Docket Item #2 & #3
BAR CASE # 2017-00020 &
2017-00021

BAR Meeting
February 15, 2017

ISSUE: Permit to Demolish and Certificate of Appropriateness for Alterations

LOCATION: 106 North Lee Street

Figure 1: Proposed south elevation with sightlines (highlighted in red) which show the change in grade from Ramsay Alley to North Lee Street; the pyramidal skylight will not be visible.

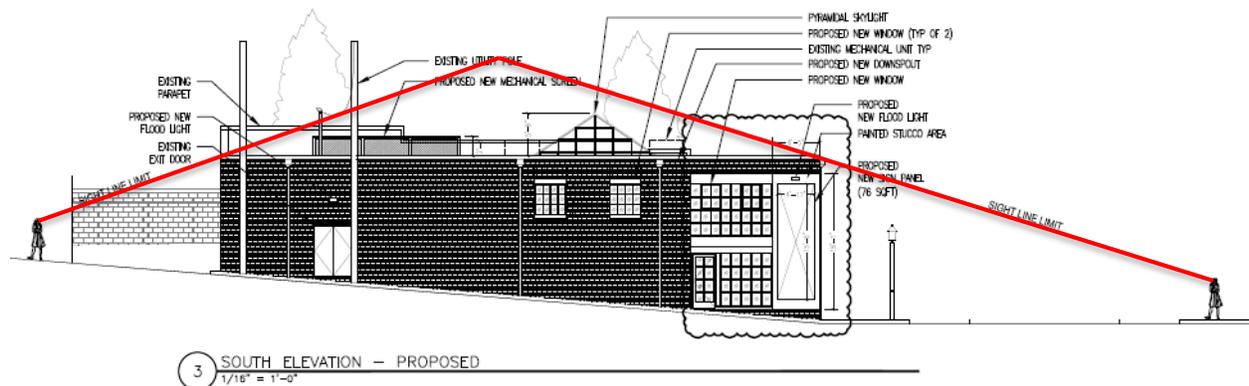
The architect asserts that the pyramidal skylight (manufactured by Super Sky Products Enterprises, LLC) will not be seen from any public right-of-way [Figures 1 and 2]. It, therefore, does not fall under BAR review and will not be considered as a part of the Certificate of Appropriateness. Similarly, staff believes that the 12 Wasco-brand, Thermalized Skydomes will not be visible from any public right-of-way, obscured by the existing parapets as well as by their positions on the flat roof, and therefore cannot be considered in this discussion.

Figure 8: Proposed east elevation.

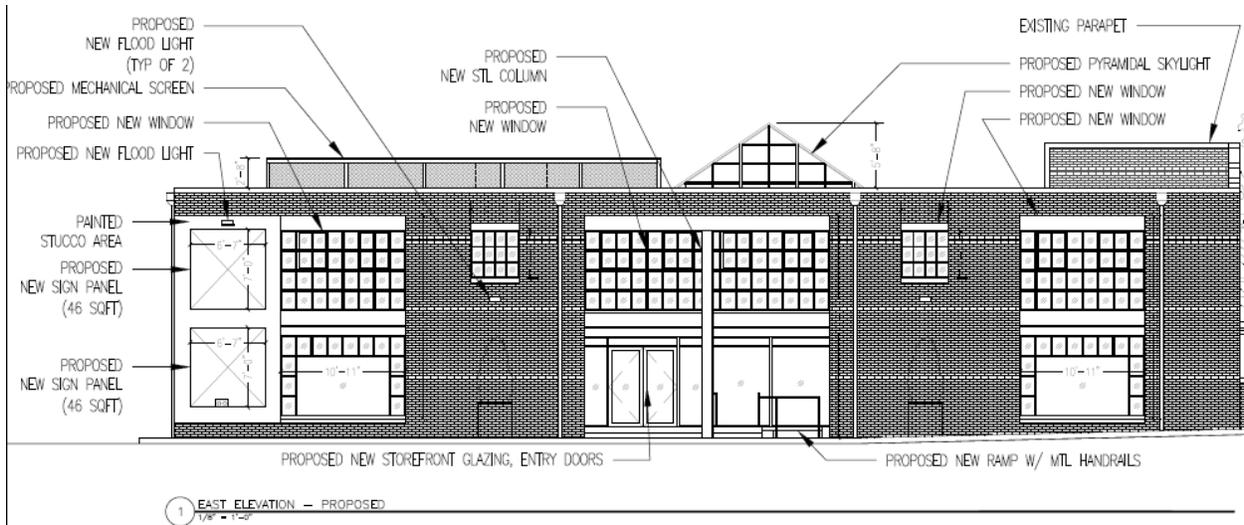
The primary alterations to the North Lee Street façade are the enlargement and reconfiguration of the existing multi-level fenestration; the addition of two new windows to the second floor; the reconfiguration of the entry; and plastering the southeast corner of the façade in order to paint signage. (see Figure 8)

The façade is divided visually into eight structural bays, in which the second, fourth, fifth, and seventh bays are glazed. Currently, the façade sports two large plate-glass, storefront windows flanked by two-light sidelights and one-light transoms on the second and seventh bays. The applicant wishes to demolish a 49-square-foot area above each window in order to enlarge the apertures, creating fenestration that spans the two floors (17-feet and nine inches high by ten feet and 11 inches wide). The new apertures will hold multi-light, fixed windows (portions of which have two operable, outward-projecting casements) on the second floor and fixed, plate-glass storefront windows surrounded on three sides by multi-light panes on the first floor. Similarly, the centralized entrance (in the fourth and fifth bays) now holds a large, multi-light transom that the applicant wishes to replace with a large expanse of glass on the upper floor: another multi-light, fixed window with four operable casements that will match those flanking it. This will require demolishing 96 square feet above of fabric the upper threshold of the transoms to enlarge the current aperture. Finally, the applicant proposes to remove the three existing awnings currently installed above the four fenestrated bays in order to give unobstructed views of the new curtain walls.

In addition, the applicant wishes to demolish a further 44 square feet of building material on the second floor (in the third and sixth bays) in order to install two, 22-square-foot, multi-light fixed windows between the two end curtain walls and the central entrance. The proposed replacement windows are “heavy commercial,” EFCO, Series 550-I (Project-Out) Thermal, Architectural Grade Projected Flush-Face windows which are double-glazed, with aluminum frames field painted black. The applicant must ensure that the windows meet the *Alexandria Replacement Window Performance Specifications*, in that “multi-light insulated glass windows must have permanently fixed muntins on both the interior and exterior, with spacer bars between the glass that are a non-reflective, medium value color.” Staff draws attention to this detail because the manufacturer’s specifications sheets provided suggest the “windows are inside glazed with an extruded aluminum snap-in glazing bead,” and BAR praxis has been to not support sandwich or snap-in muntins because portions tend to fall off over time. In addition, the *Alexandria Replacement Window Performance Specifications* state that “all glazing must be clear, non-reflective and without tint;” staff singles out this detail because, while the provided specifications

meet the 72% lower threshold of visible light transmission (VLT), they do not meet the through-the-glass shading coefficient between .87-1.0 (at .63) nor do they meet the reflectance standard or less than 10% (at 12% exterior and 13% interior). Staff supports the proposed aluminum storefront windows provided that the muntins be permanently affixed and that the glazing meet the BAR's requirements for value light transmission.

Alterations to the entrance entail squaring off the current angled entry vestibule by removing the storefront windows on the southwest wall and adding new storefront glazing. The rectangular entry porch will hold a liminal entry vestibule with two successive pairs of new, outward-swinging, full-glass, double doors. The recessed entry porch will be bifurcated by a new steel, non-structural column; on the north side of the column, the applicant proposes to install a new, U-shaped handicap ramp with simple metal handrails. Furthermore, the angled stairs that currently exist within the covered porch will be demolished and replaced by a raised platform, access by new stairs (two risers) aligned with the exterior wall. Manufacturer's specifications for the doors should be provided to BAR staff and the glazing should meet the value light transmission requirements as specified in *Alexandria Replacement Window Performance Specifications*.

Further details include the addition of three new exterior light fixtures: two below the proposed new windows on the third and sixth bays, which flank the entrance, and one above the proposed wall signage on the first bay. The applicant has supplied manufacturer's specifications for LED Flood Luminaire, D-Series, Size 2 (12-7/8"W x 7-3/4"H [12"OH] x 3-1/8"D) and for LED Flood Luminaire, D-Series, Size 3 (13"W x 13-5/8"H [17-1/2"OH] x 5"D); both are black, which match the window frames and other proposed architectural details. It is unclear, without a light schedule, to know which floodlight is proposed for which location, but staff supports the applicant's decision to choose models with upper/bottom visors to limit the extent of illumination. Because, in general, the BAR is concerned with the *intensity* of exterior lighting (and as per the *BAR Design Guidelines*), the applicant should ensure that "the color of the [luminescence is] appropriate to the architectural character of the building" as well meeting the requirements of the Virginia Uniform Statewide Building Code and the regulations of the local zoning ordinance. While fully supporting pedestrian safety and visibility of this commercial establishment from King Street, staff recommends review of the intensity of this lighting after installation to insure that it is not out of character with the streetscape. If it is not, the lumens must be reduced.

Lastly, the applicant wishes to plaster 168 square feet on the southeast corner (first bay) in order to paint two new sign panels equaling 92 square feet in the future. The commercial-grade, Quikrete Stucco will be applied in a base and finish coat and painted black. Within this field, two primary-colored panels will be painted, within which text advertising the future occupants will presumably be painted. Although it is general BAR praxis not to support the application of paint or stucco to previously unpainted or un-clad masonry, in this case, BAR staff supports the alteration to this Mid-Century warehouse construction where the brick has already been painted. Because the signage portion is in a conceptual phase, the applicant is asking the BAR to approve the sign area with final approval of specific design within the painted stucco areas to be approved by BAR staff administratively at a future date, in accordance with the BAR's sign policy.

1. All new windows must meet applicable criteria in the *Alexandria Replacement Window Performance Specifications* (contained in the BAR's adopted window policy):

- a. Multi-light insulated glass windows must have permanently fixed muntins on both interior and exterior.
 - b. All glazing must be clear, non-reflective, and without tint;

- i. through-the-glass shading coefficient must be between 0.87-1.0.
 - ii. the reflectance must be less than 10%.
2. All new and replacement doors and trim must comply with adopted BAR policies.

Figure 7: Revised proposed south elevation

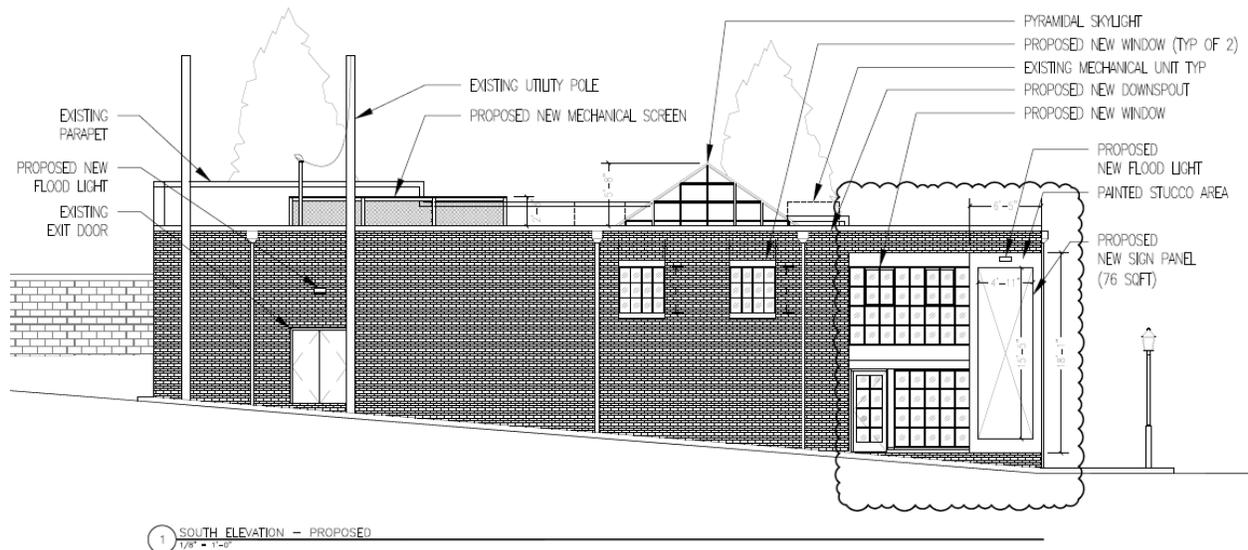
The majority of alterations proposed for this seven-bay side are focused primarily on the southeast corner, on bays four through seven, and entail adding a series of windows to an almost-blind wall [Figure 7]. Most significantly, the applicant proposes to create a curtain wall by installing a multi-light, fixed window with two operable casements on the second floor equivalent to those on the façade, as well as a multi-light, fixed window on the first floor. Since his first submission, the applicant has revised his drawings: whereas he had a storefront window surrounded on three sides with multi-light panes (like those on the façade) on the first floor, now he requests a fixed multi-light window and a multi-light door. In addition, the applicant wishes to install two new fixed, multi-light windows on the second floor just west of the curtain wall (the fourth and fifth bays). They are similar in size and style to the two proposed on the façade.

Like on the façade, the applicant wishes to plaster 106 square feet on the southeast corner in order to paint one new sign panel encompassing 76 square feet. The applicant also wishes to install two new exterior lights on this elevation – one above the signage on the seventh bay and one above the existing fire-exit door on the second bay. The applicant also proposes to remove two existing downspouts on the fourth and seventh bays, and replace one by adding a new one to the fifth bay.
